ADDENDUM NO. 1
Amelia River Waterfront Stabilization Parking Lots C & D
City of Fernandina Beach
Invitation to Bid # 21-06
Issued: May 25, 2021

III. Changes to Drawings: (See attached)

Amelia River Waterfront
 Stabilization
 Parking Lots C & D
 Town/City: Fernandina Beach
 County: Nassau State: Florida

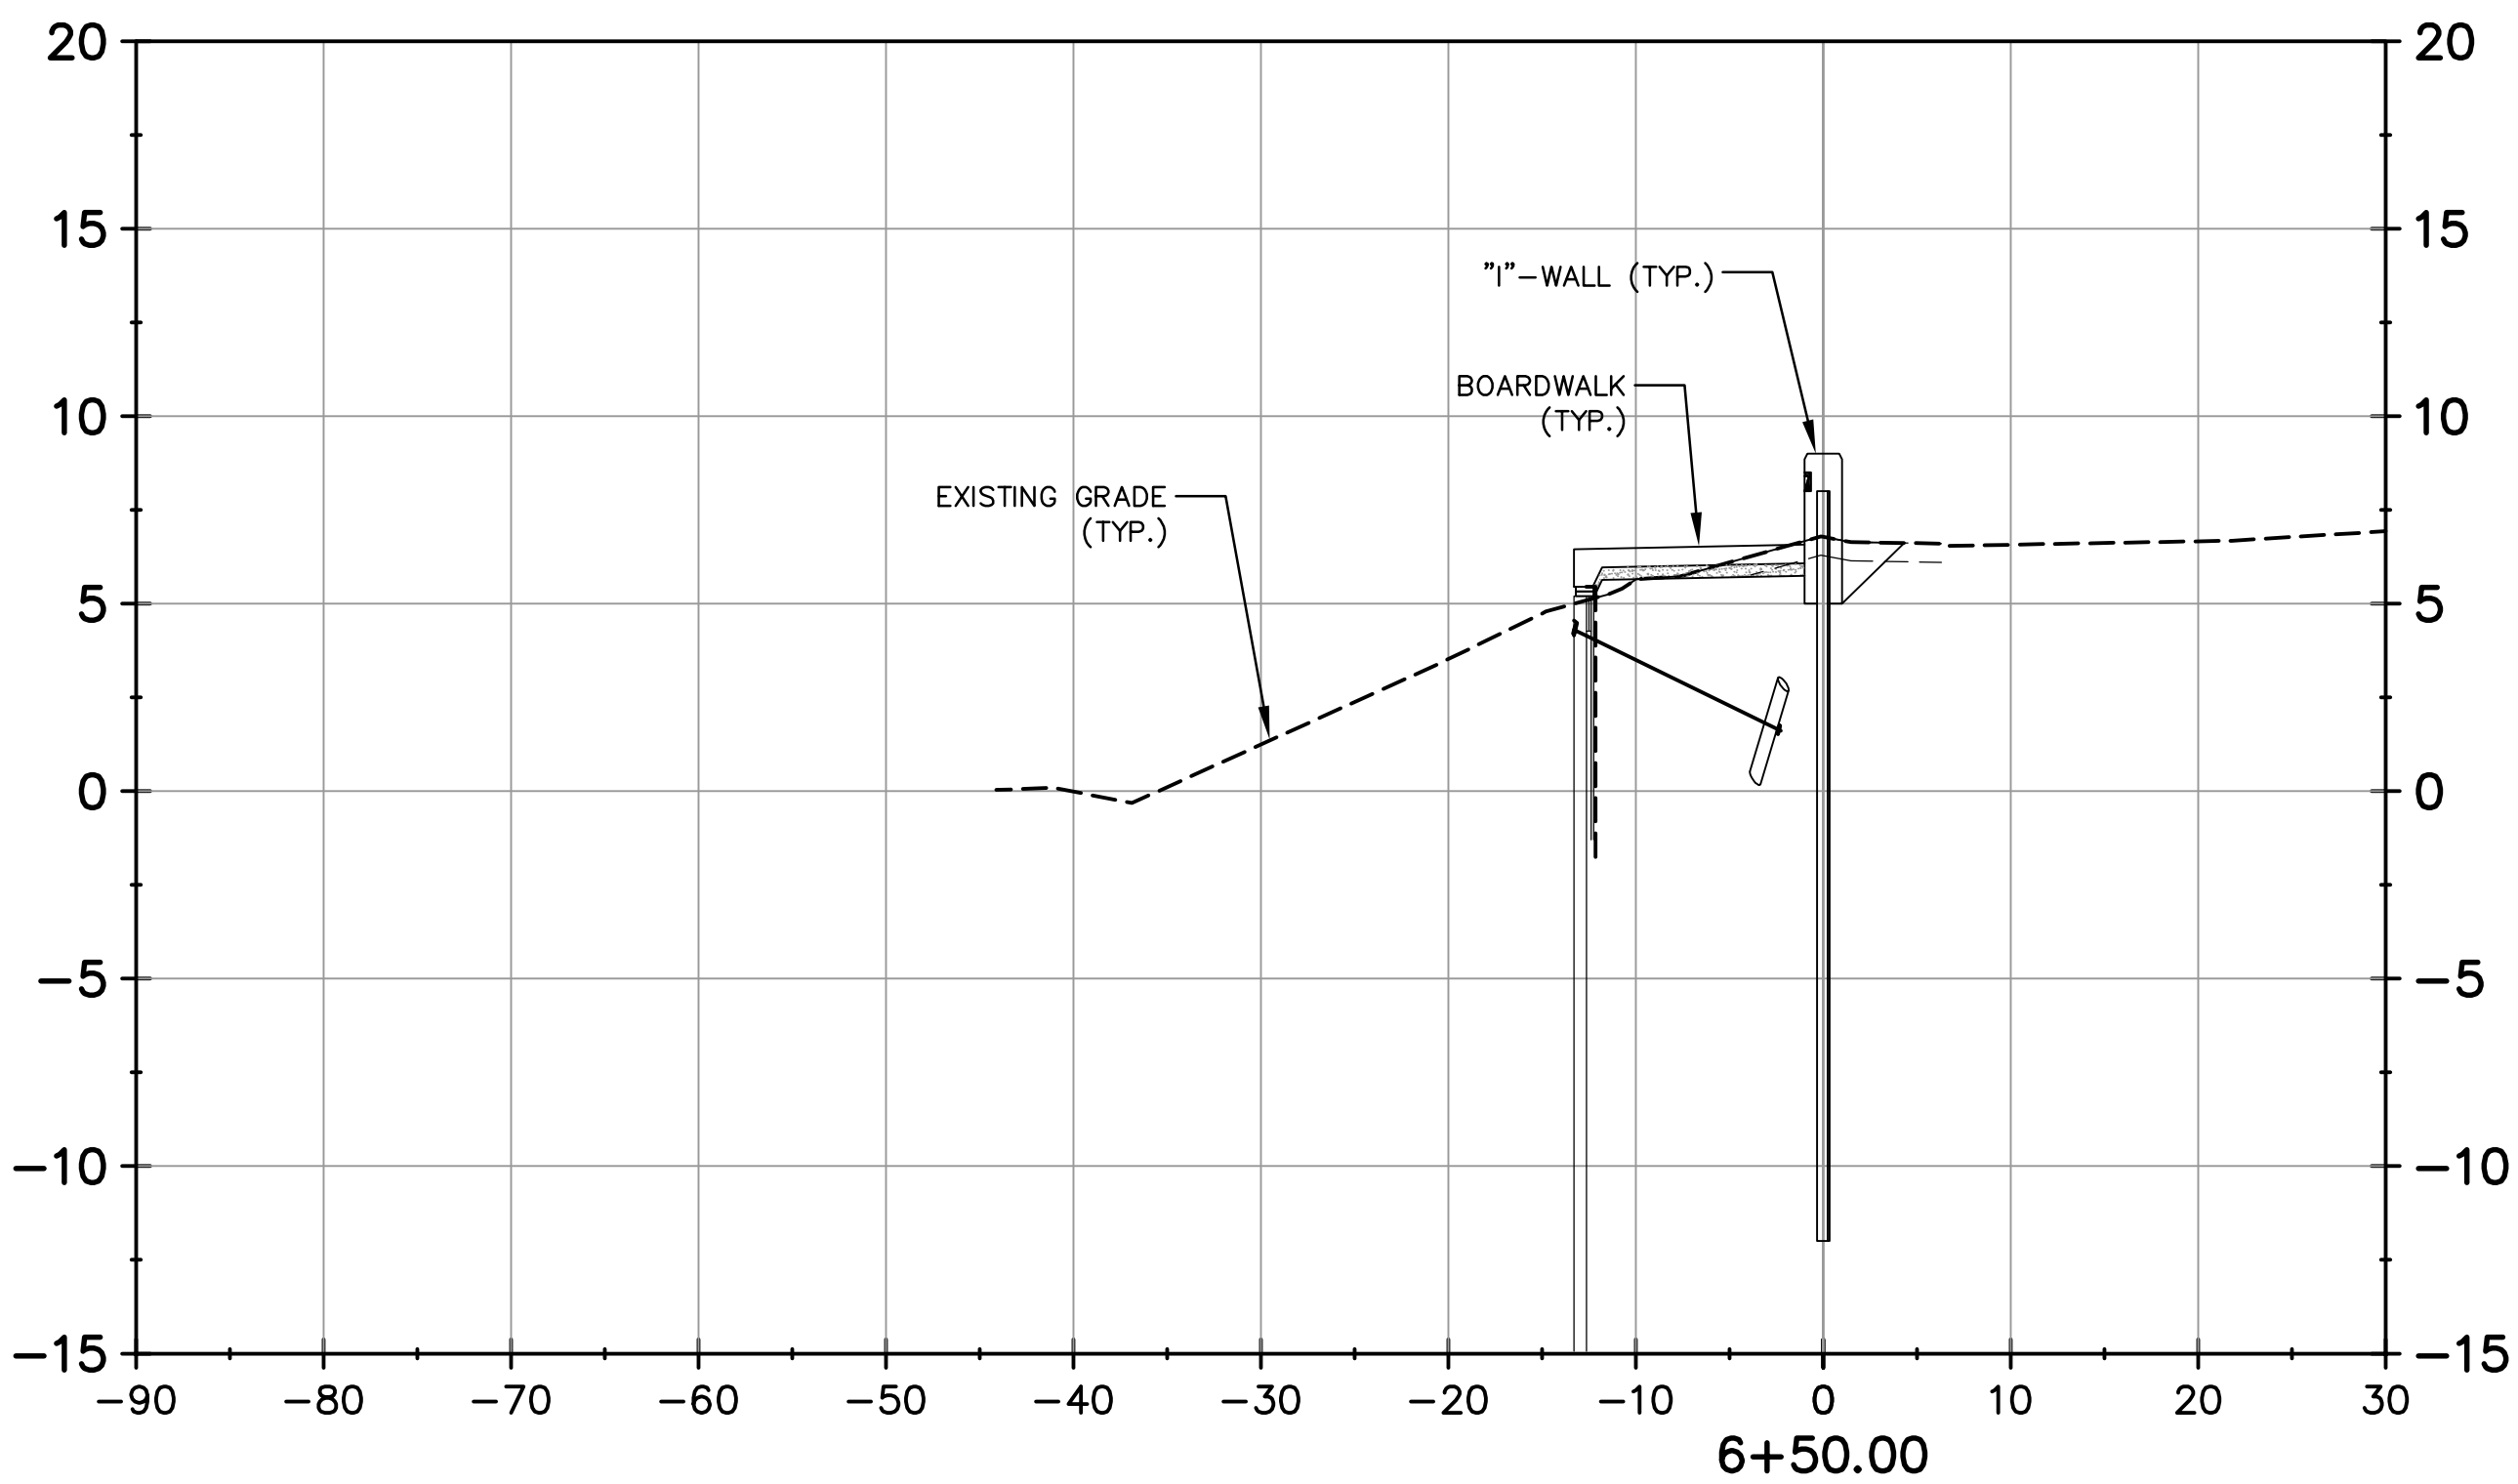
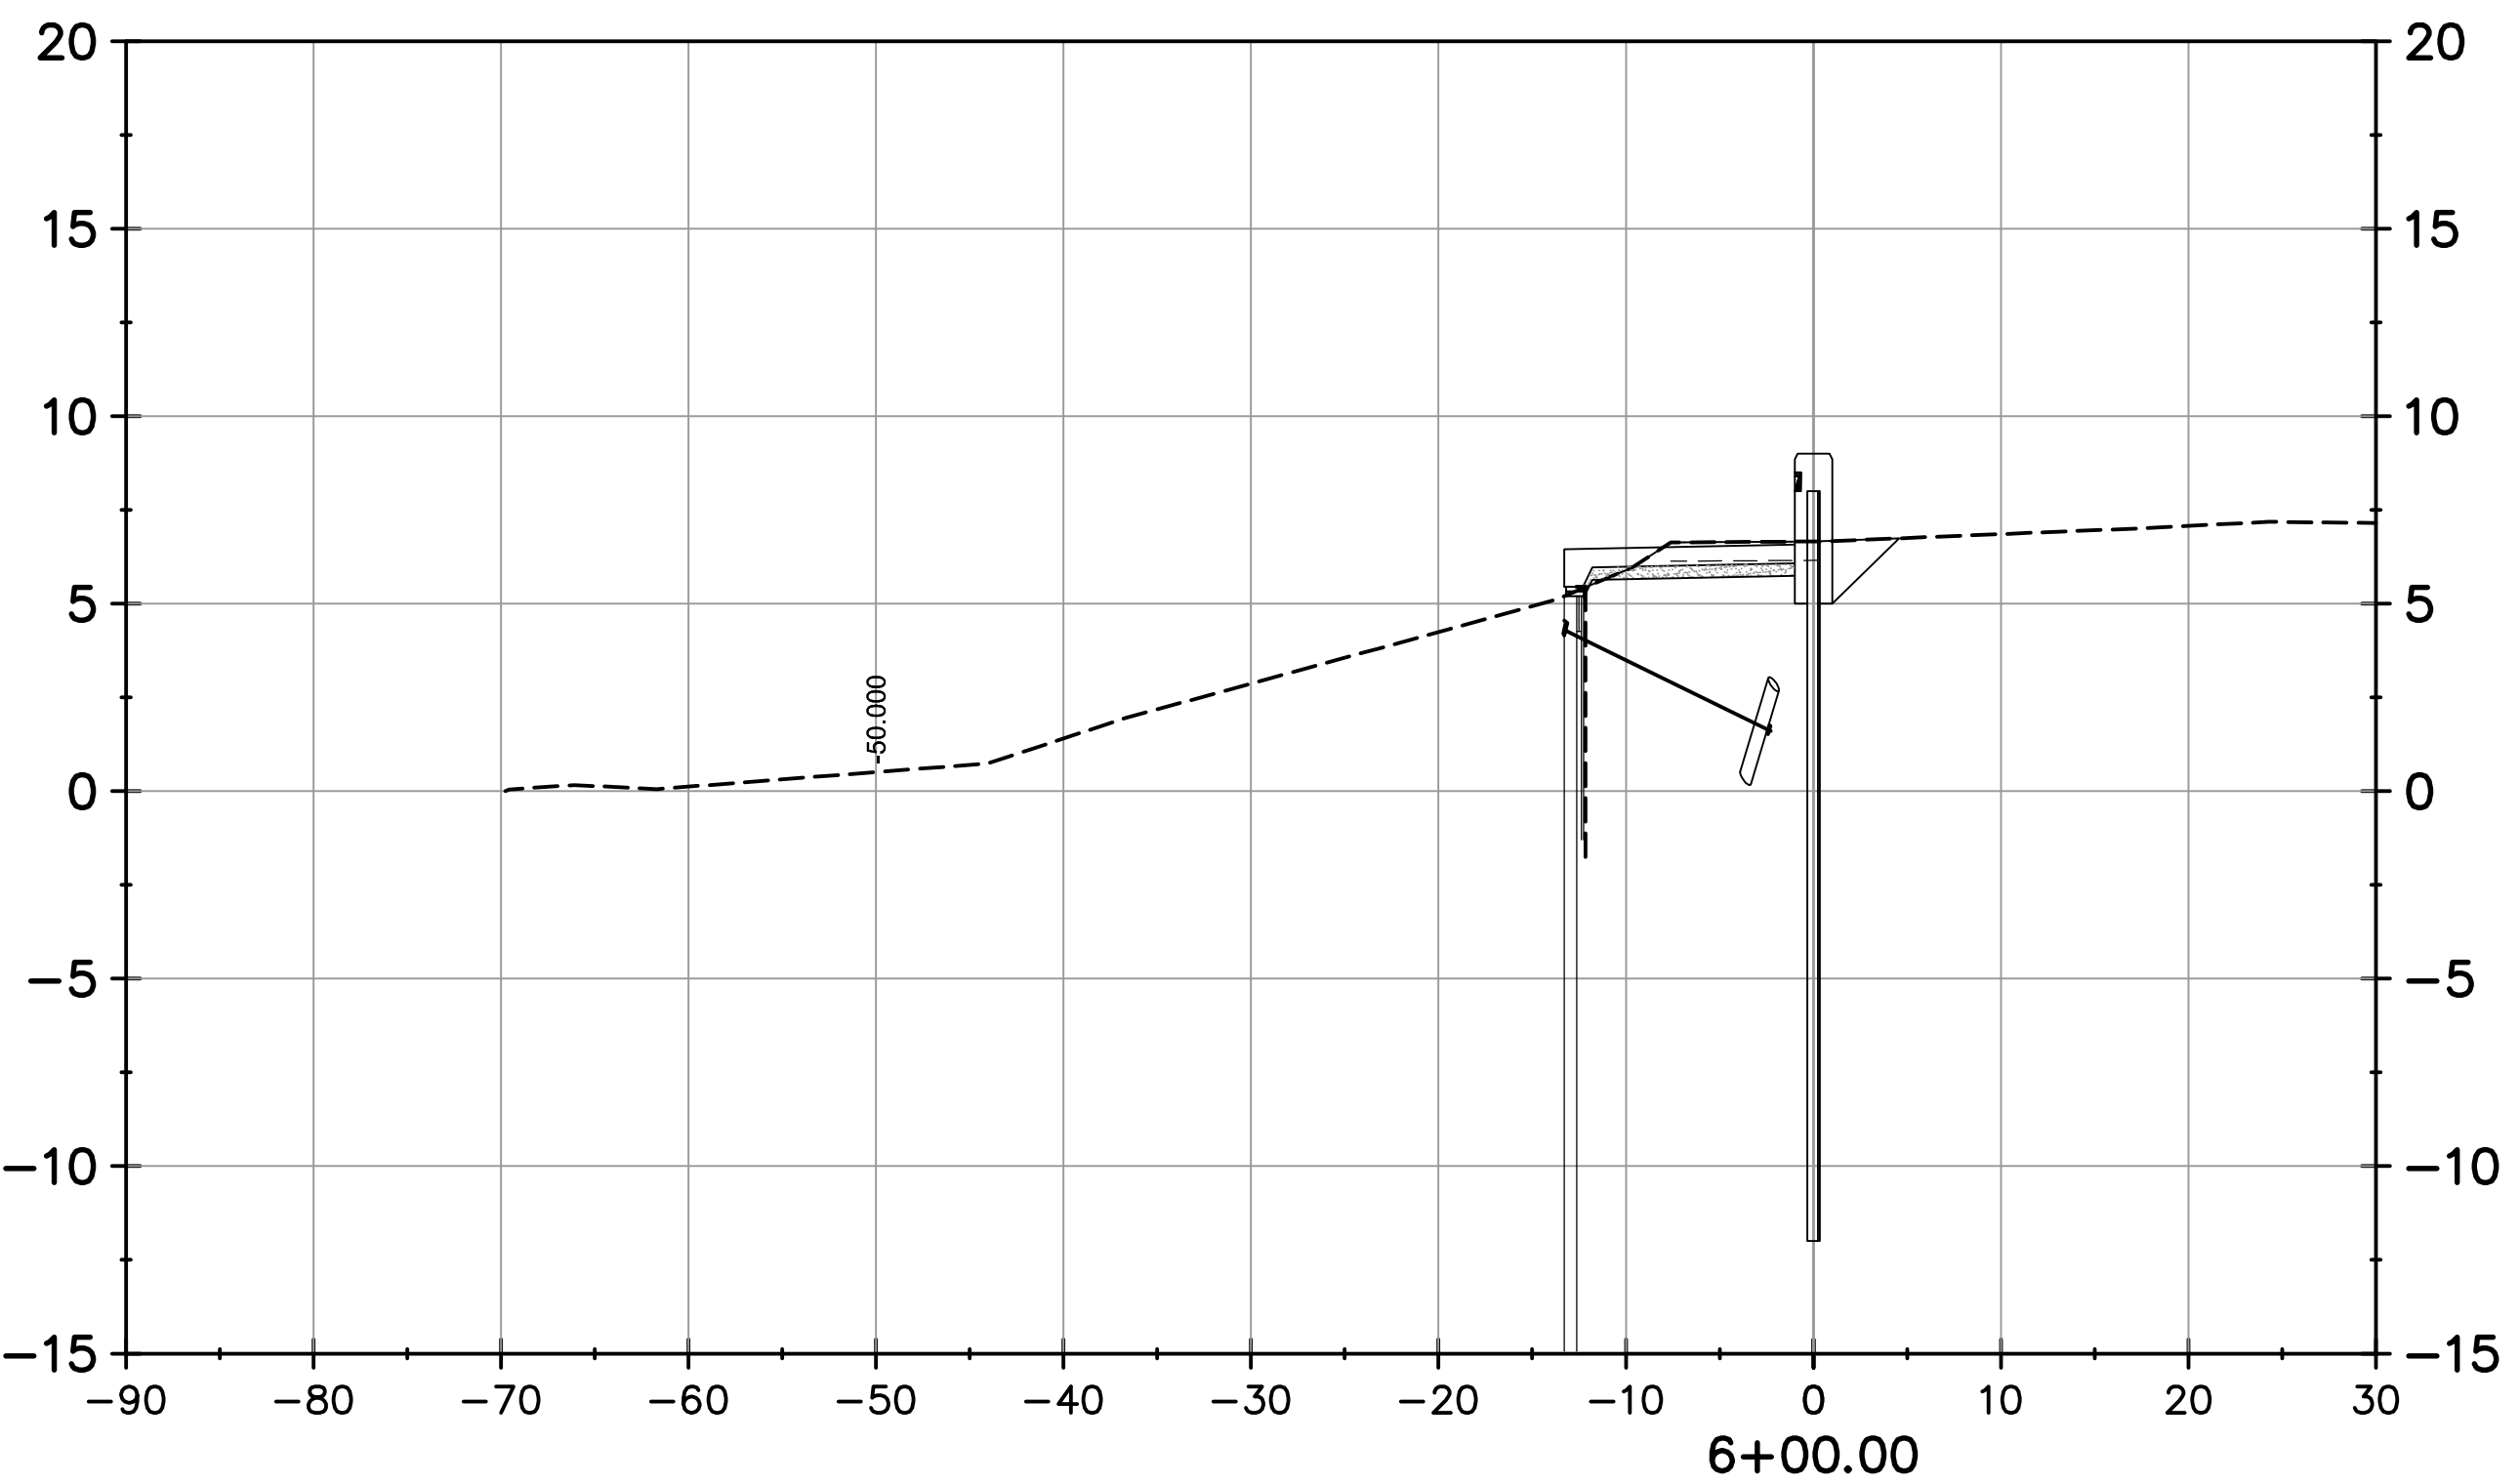
- 22) Sheet C6-3 - Revised I-Wall & Boardwalk Alignment and Cross Sections Adjusted.
- 23) Sheet C6-4 - Revised I-Wall & Boardwalk Alignment and Cross Sections Adjusted.
